Workshop Manual

electrical wiring SUPPLEMENT

CARISMA2003

This publication contains information on major changes which have occurred as a result of modifications for the year model CARISMA.

AUTOMATIC AIR CONDITIONER

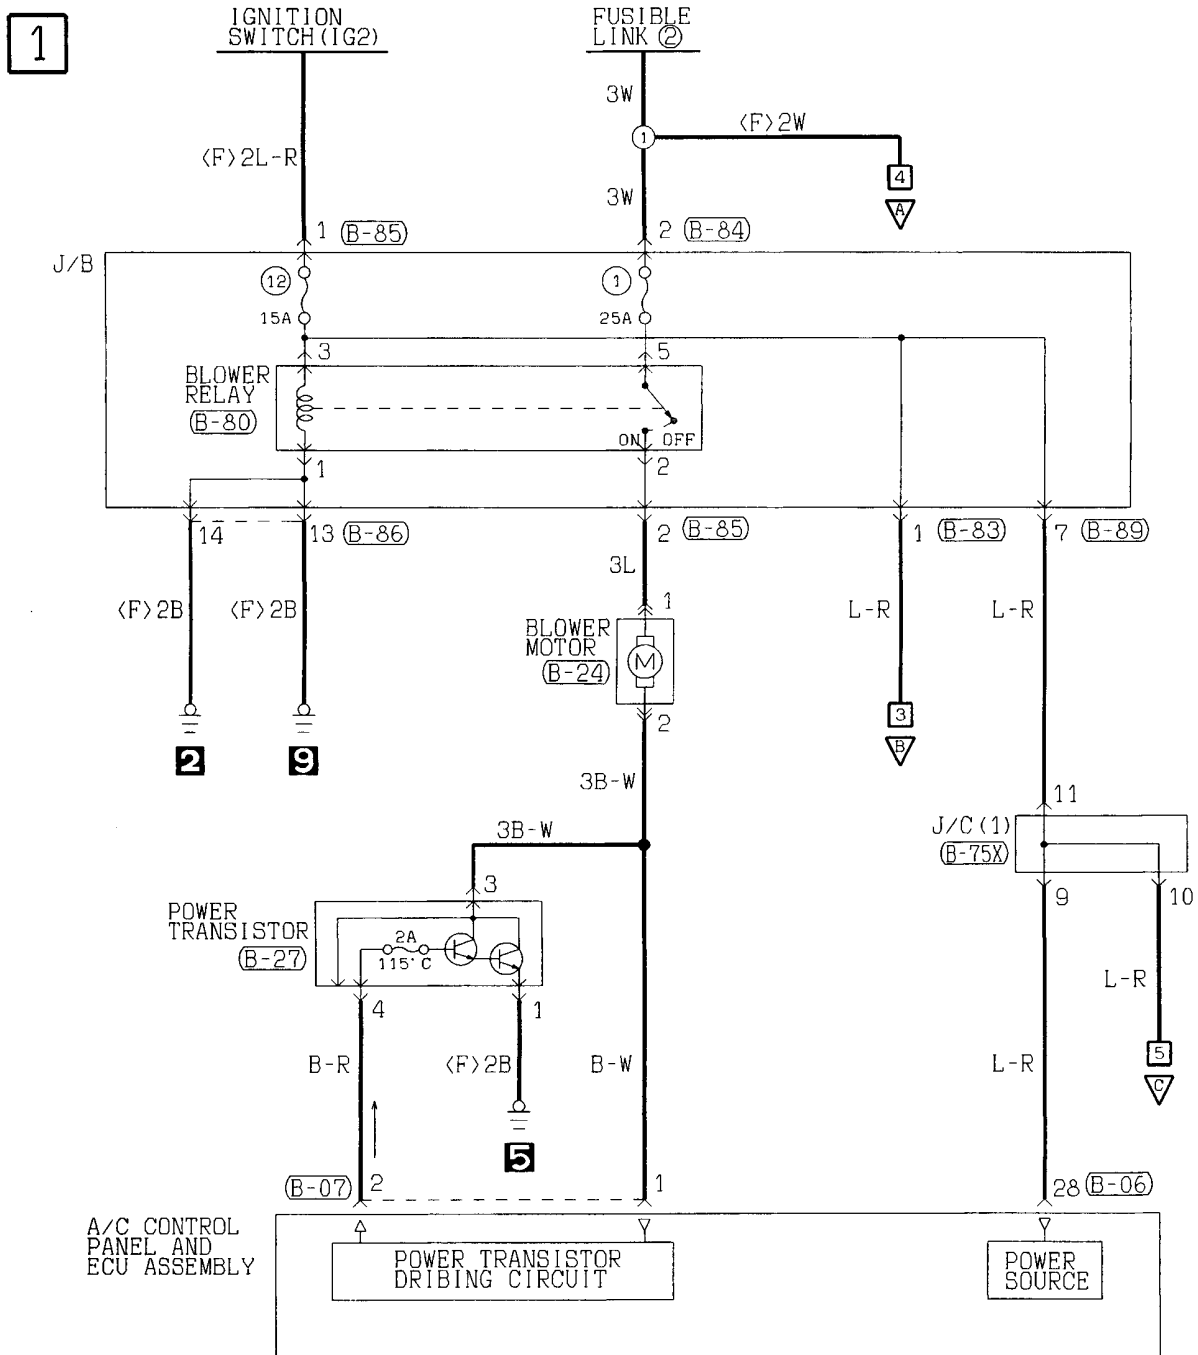
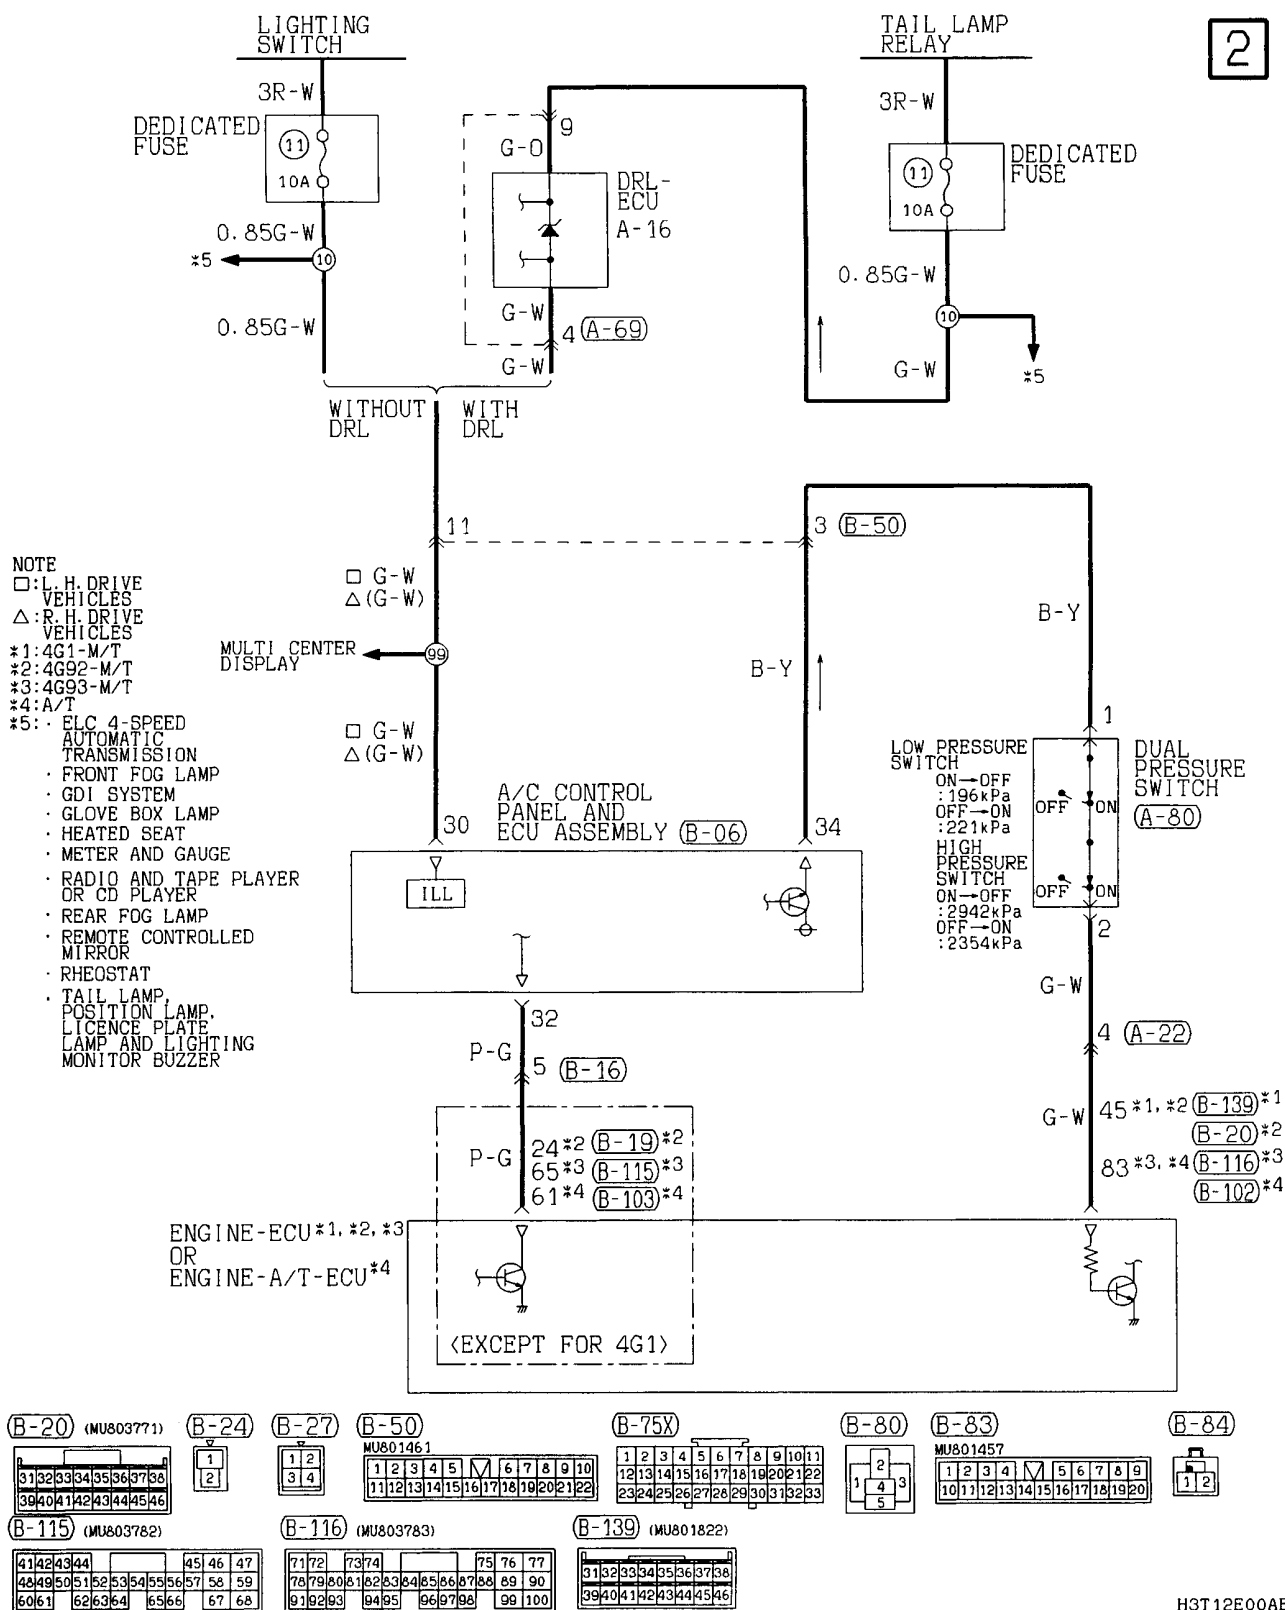
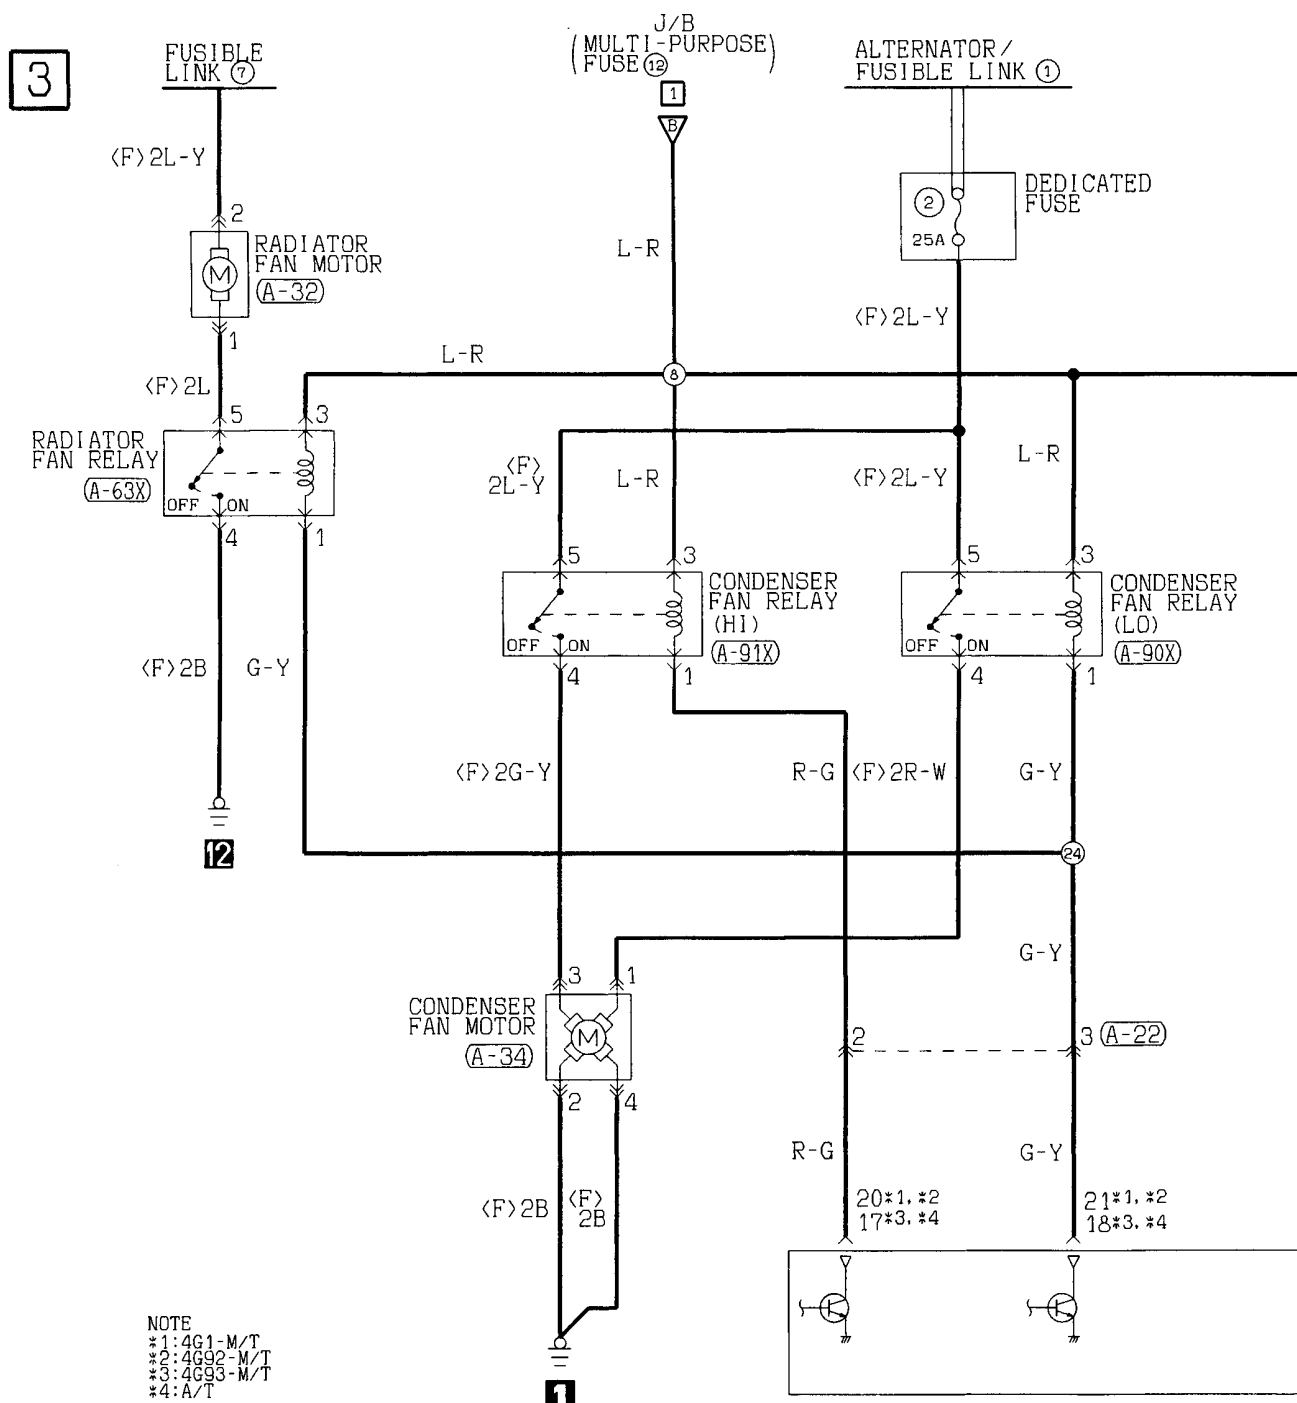
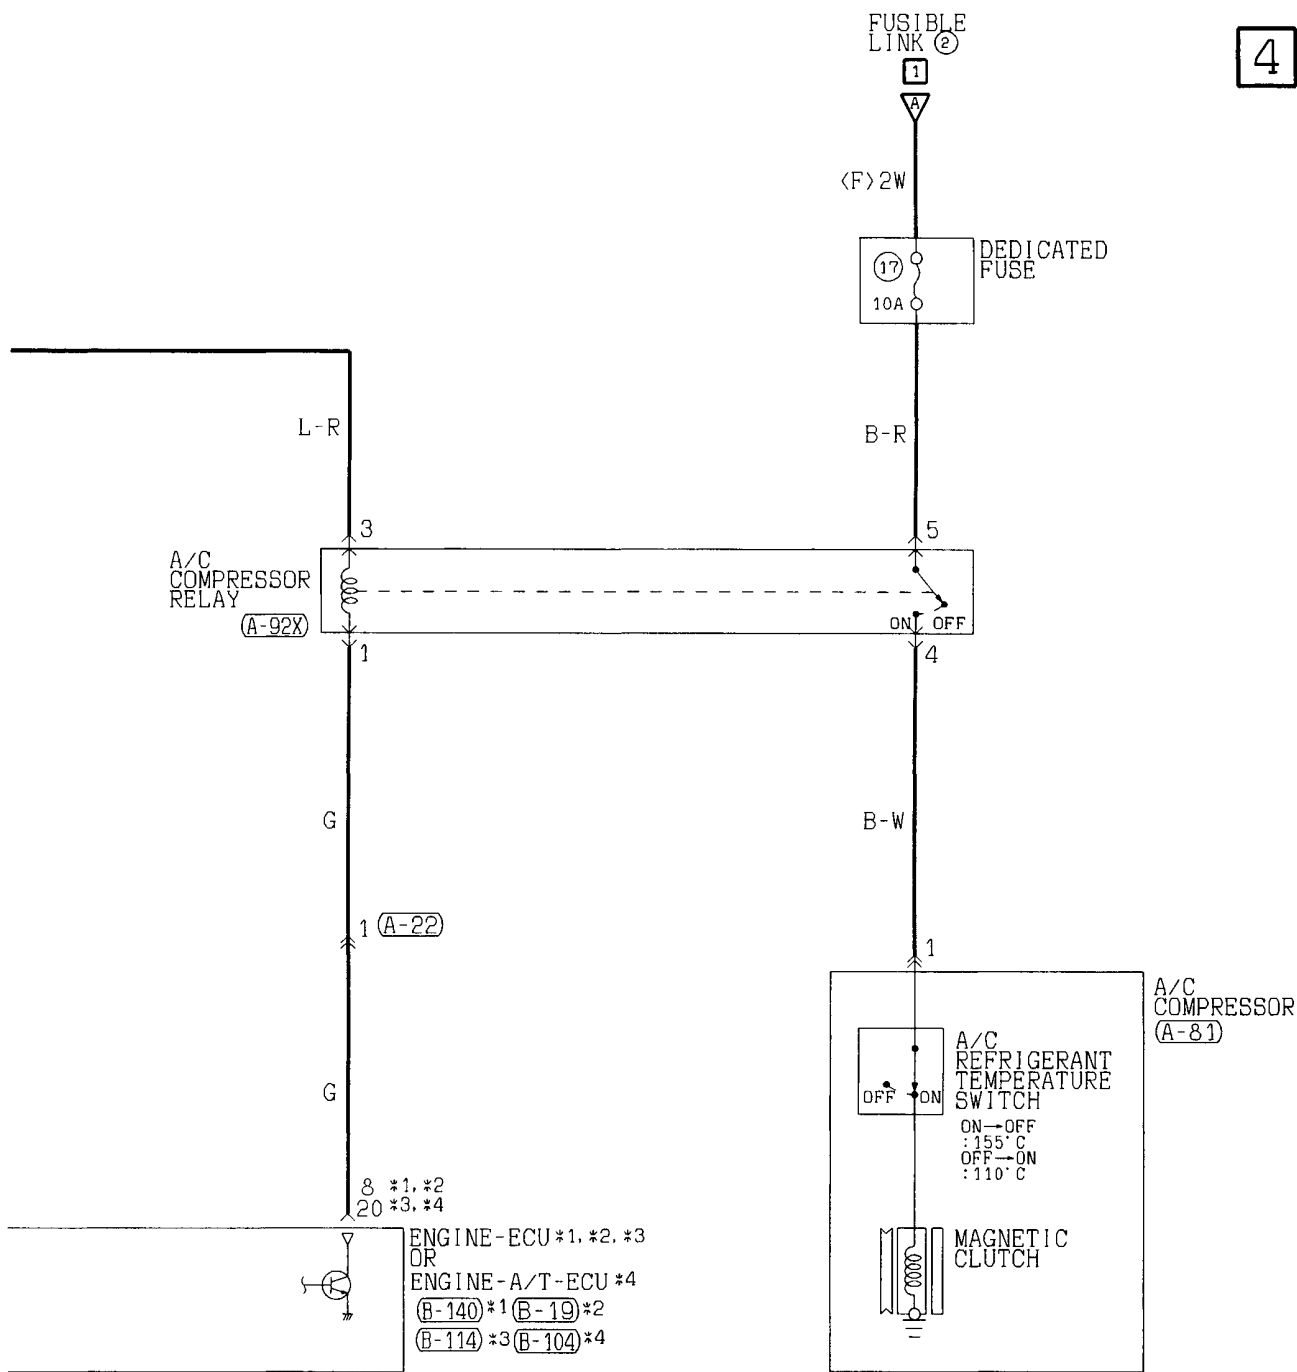
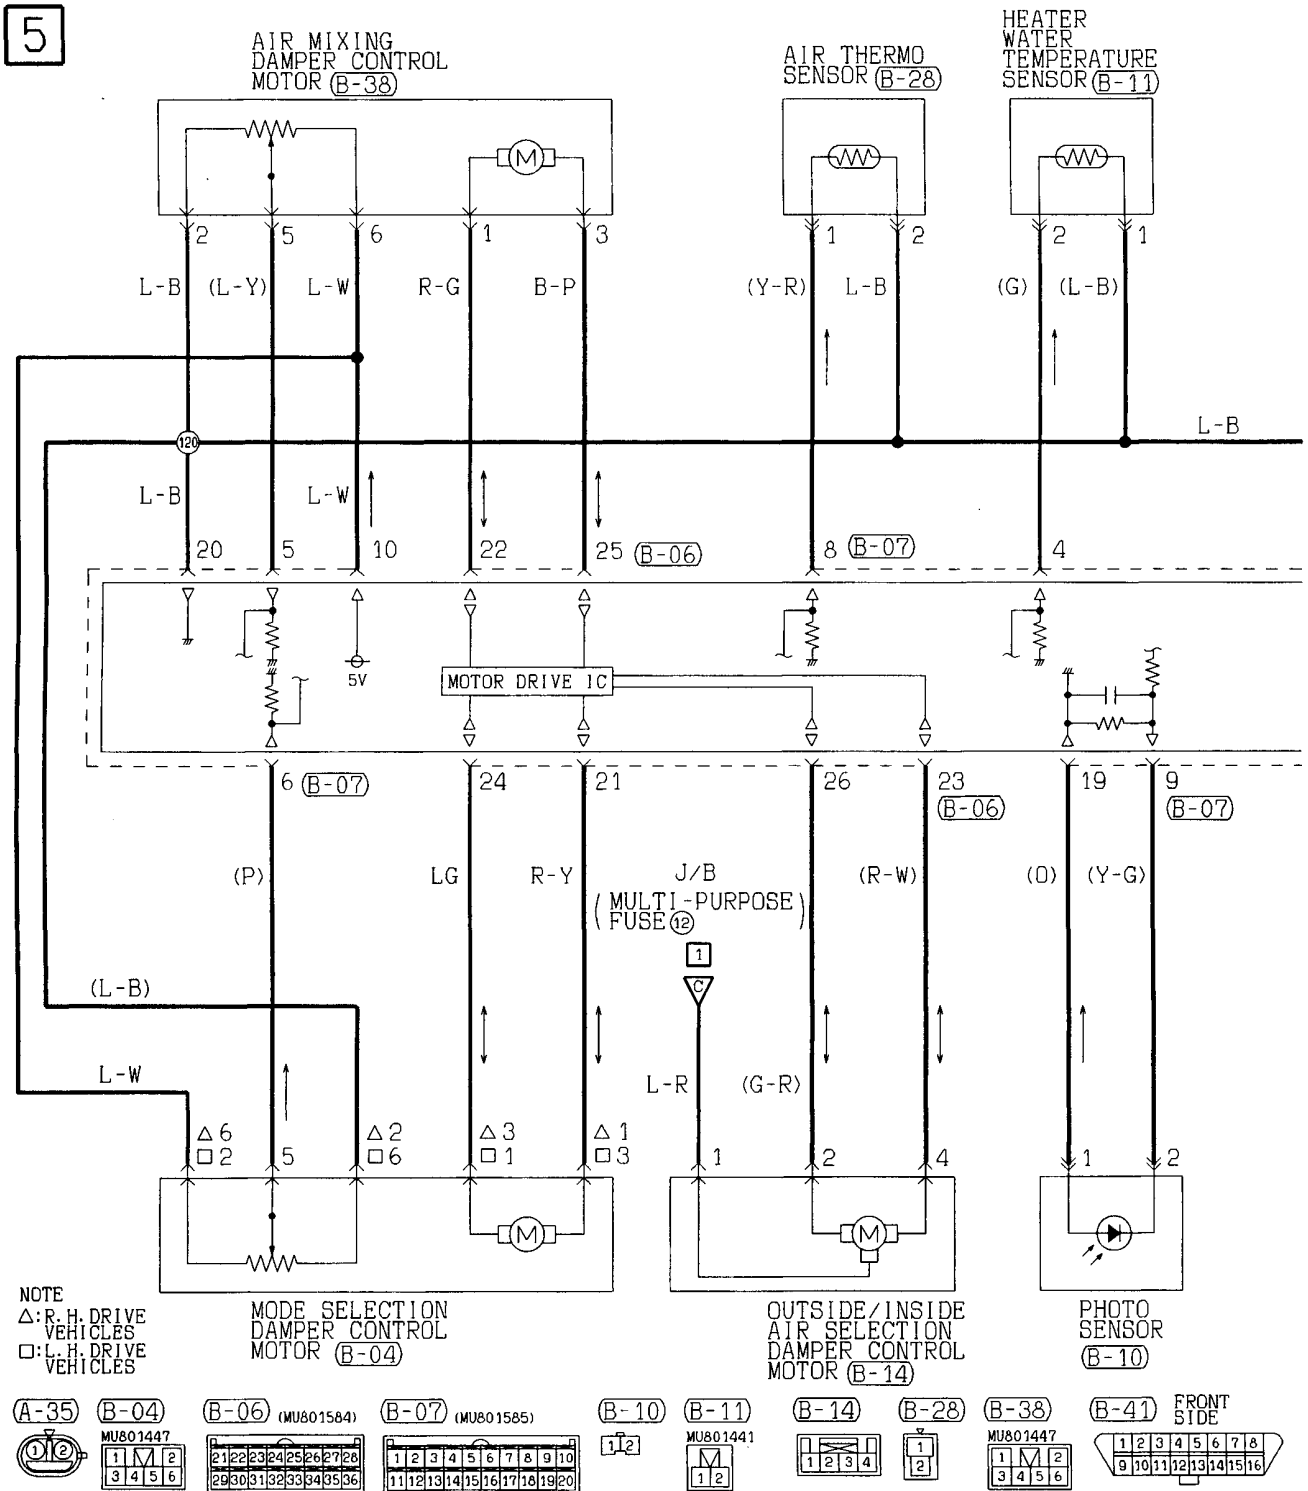
HEADLAMP WASHER	–	–	The colour of the wire for terminal 4 of the headlamp washer relay connector (A-65X) has been changed from R-W to G-O.
DEFOGGER AND DOOR MIRROR HEATER	Vehicles with full-auto air conditioner	4-18	The A/C control panel illumination circuit has been changed to correspond to the addition of vehicles with DRL. <RHD>
MULTI CENTER DISPLAY	Petrol-powered vehicles	4-22	- The multi center display unit illumination circuit has been changed to correspond to the addition of vehicles with DRL. <RHD> - The colour of the wire for terminal 1 of the output shaft speed sensor connector (A-29) has been changed from R to B. <GDI>
	Diesel-powered vehicles <F9Q>	4-28	The multi center display unit illumination circuit has been changed to correspond to the addition of vehicles with DRL. <RHD>
RADIO AND TAPE PLAYER OR CD PLAYER	–	–	The tweeters (LH and RH) have been abolished.
SUNROOF	–	4-34	As the sunroof system has been changed, the sunroof-ECU has been changed to a sunroof assembly and the inner circuit has been changed.
